February 22, 2021

**Re: Comments of Horizon West Transmission, LLC on the Draft Environmental Impact Report for the Estrella Substation and Paso Robles Area Reinforcement Project, December 2020 (California State Clearinghouse No. 2018072071)**

**Figure 2. Preliminary Plan**

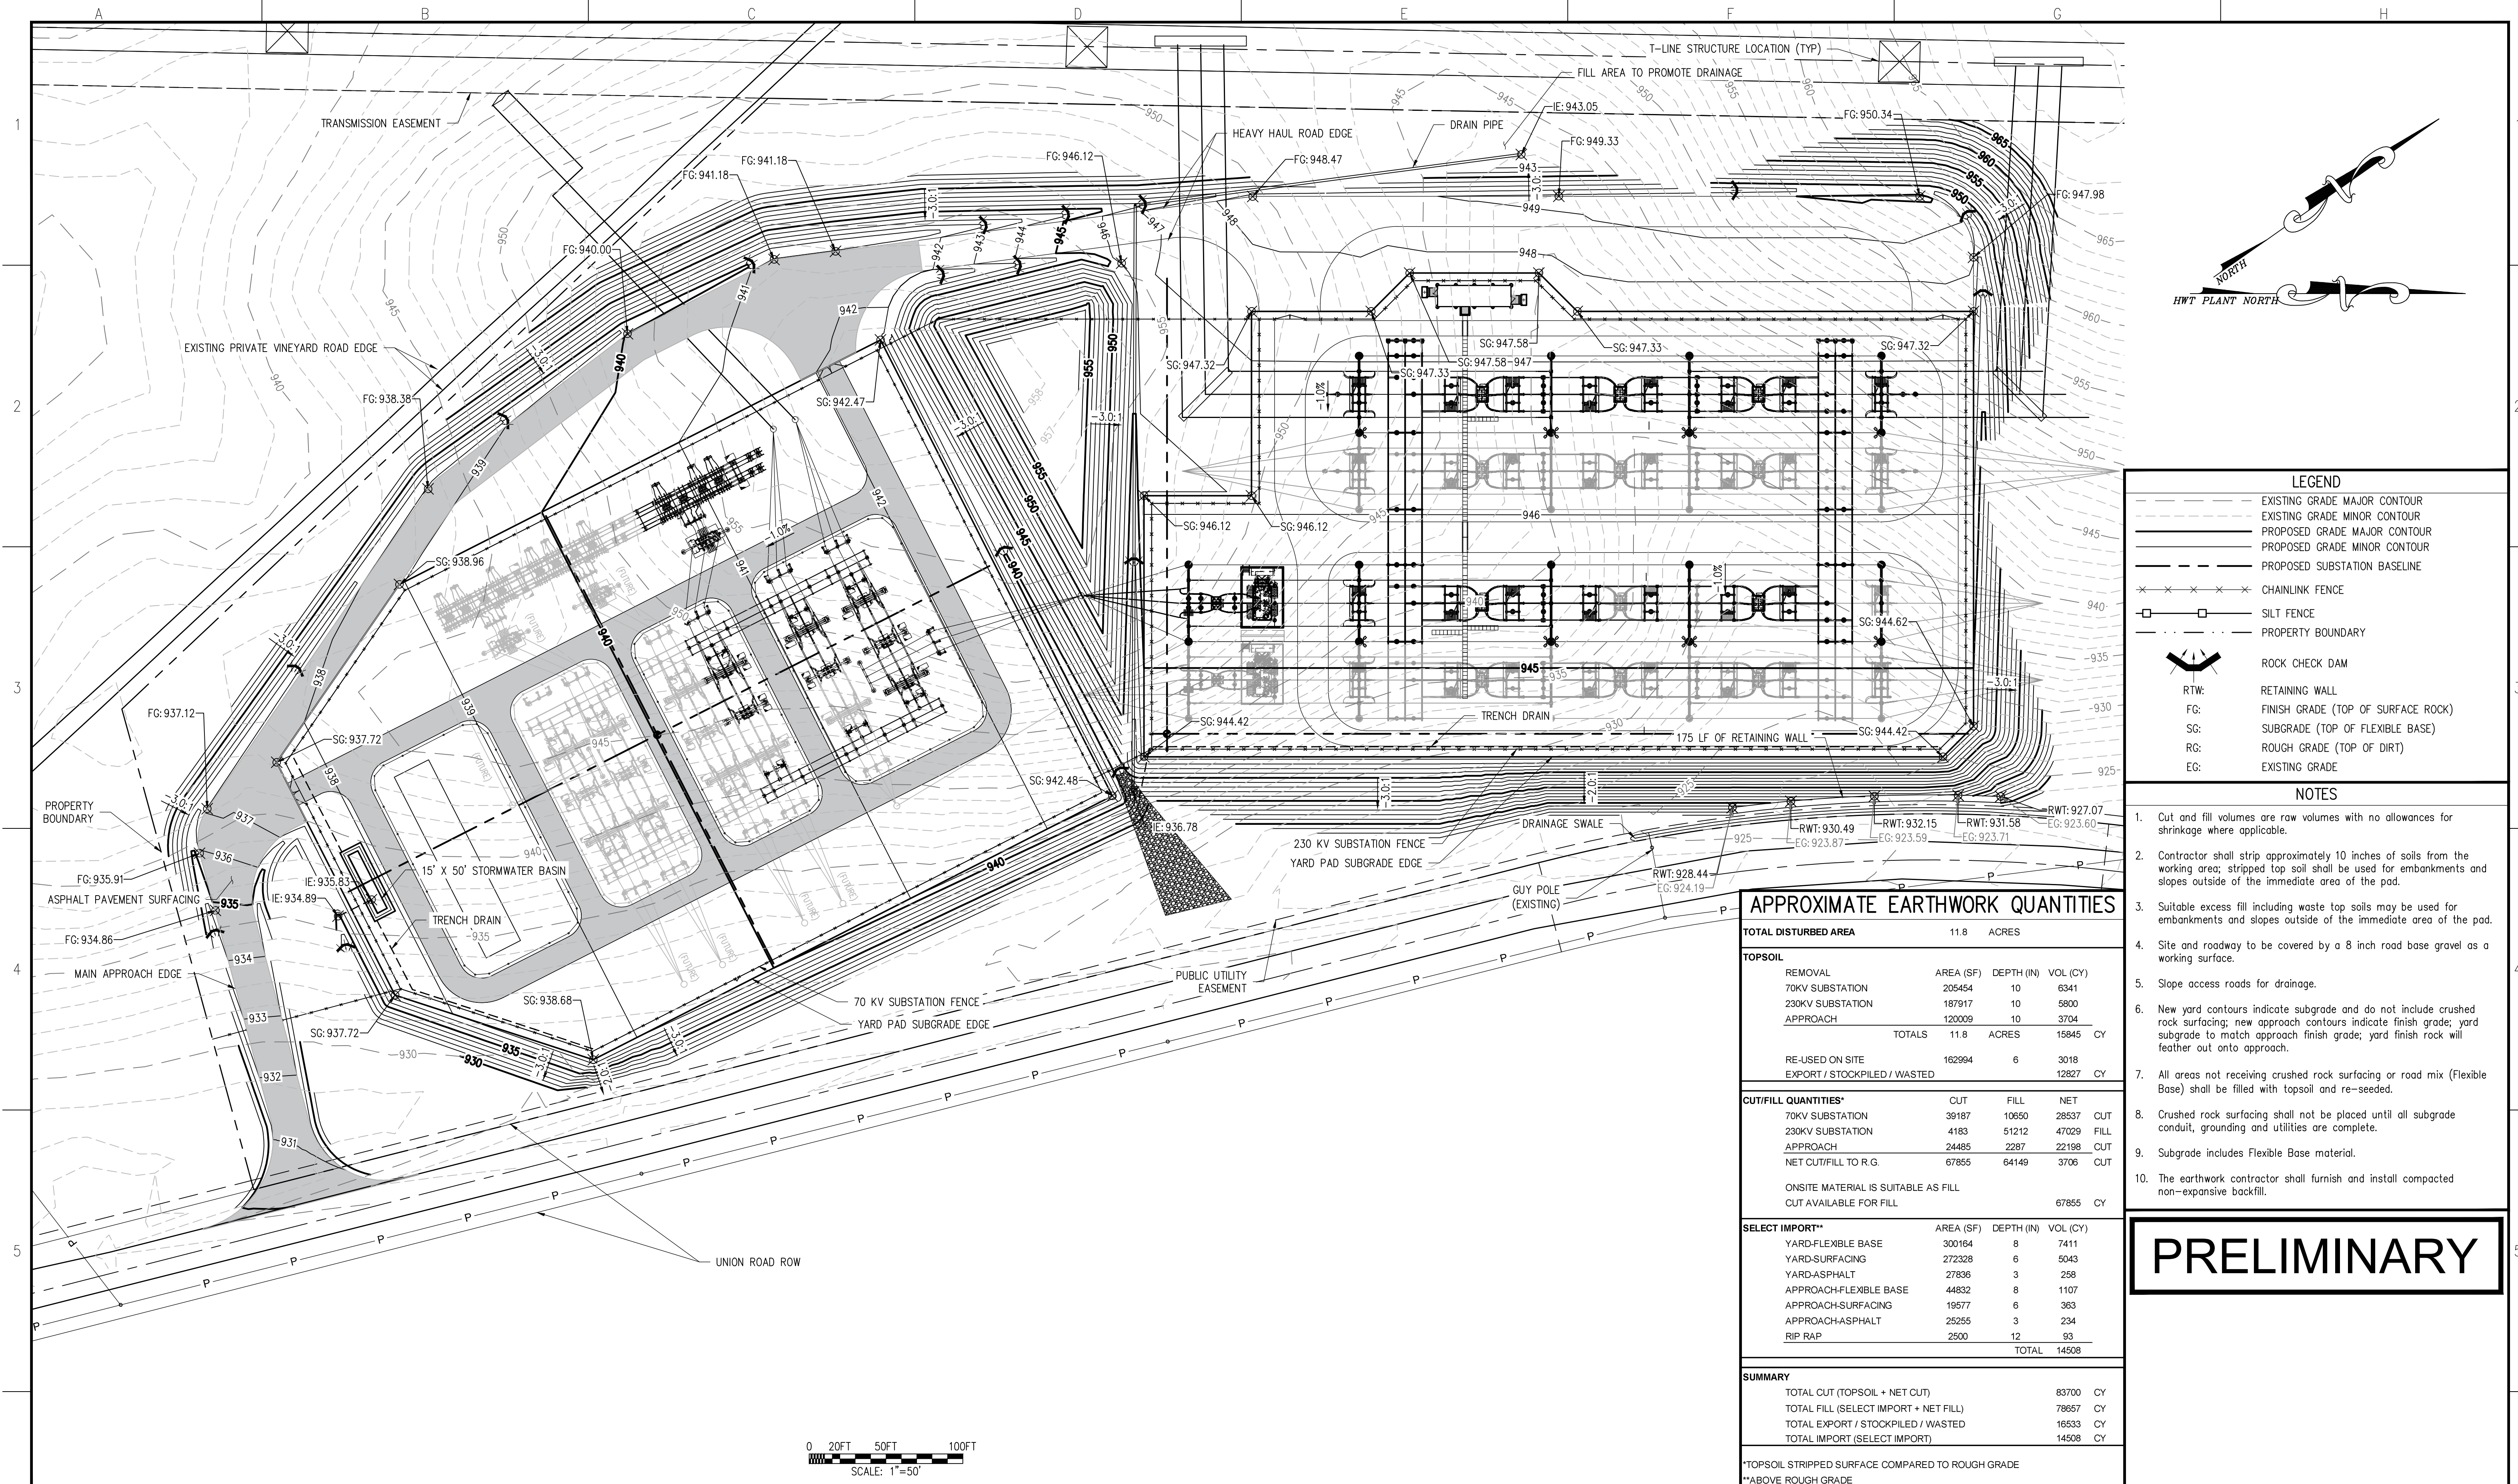
At its closest point, the fence line will be located approximately 64 feet northwest of Union Road, as shown in Figure 2 in **Attachment 1** hereto. Without this change, the design would preclude access to the five-acre addition to the site. This slight reorientation will require approximately 72,000 cubic yards of cut and fill, which will be balanced on site to the extent feasible. The MPR will only result in a slight reconfiguration of the yard equipment and will not affect the type of electrical equipment to be housed within the site's fence line as originally proposed.

The MPR would slightly reorient the 230 kilovolt (kV) and 70 kV yards and associated equipment closer to Union Road to allow access to the additional five acres of land in the northeast portion of the parcel. At its closest point, the fence line for the 230 kV and 70 kV yards would be located approximately 64 feet northwest of Union Road. The configuration of the electrical equipment for the 230 kV and 70 kV substations is provided in Figure 2. The slight reorientation of the substation facilities would require approximately 68,000 cubic yards of cut and fill, which would be balanced on site to the extent feasible. The MPR would extend construction activities at the substation site by one week. The MPR would only result in a sight reconfiguration of the yard equipment and would not affect the type of electrical equipment to be housed within the substation fence line, as originally proposed.

**Figure 2-1**  
Existing Transmission System

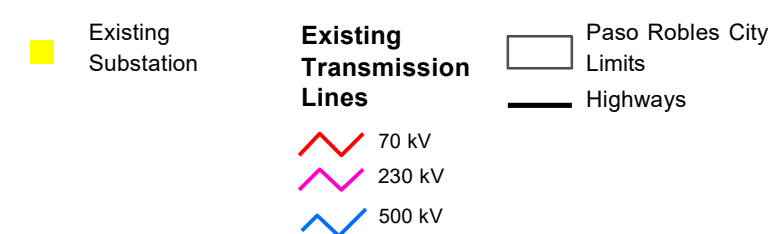
<b>CHAPTER 2 - PROJECT DESCRIPTION</b>		
2-4	Figure 2-1	The 500kV line is north of the 230 kV line, not south as currently depicted in the figure.
2-15	Topography in the vicinity of the Proposed Project is generally rolling hills, with existing elevations ranging from approximately 920 feet to 960 feet above mean sea level	<p>Please revise text to read:</p> <p>Topography in the vicinity of the Proposed Project is generally rolling hills, with existing elevations ranging from approximately 920 feet to <del>960</del> <u>970</u> feet above mean sea level</p>
2-15	Topography in the vicinity of the Proposed Project is generally rolling hills, with existing elevations ranging from approximately 920 feet to 960 feet above mean sea level.	<p>The maximum elevation of substation parcel is approximately 970 feet.</p> <p>Revise text to read:</p> <p>Topography in the vicinity of the Proposed Project is generally rolling hills, with existing elevations ranging from approximately 920 feet to <del>960</del> <u>970</u> feet above mean sea level.</p>
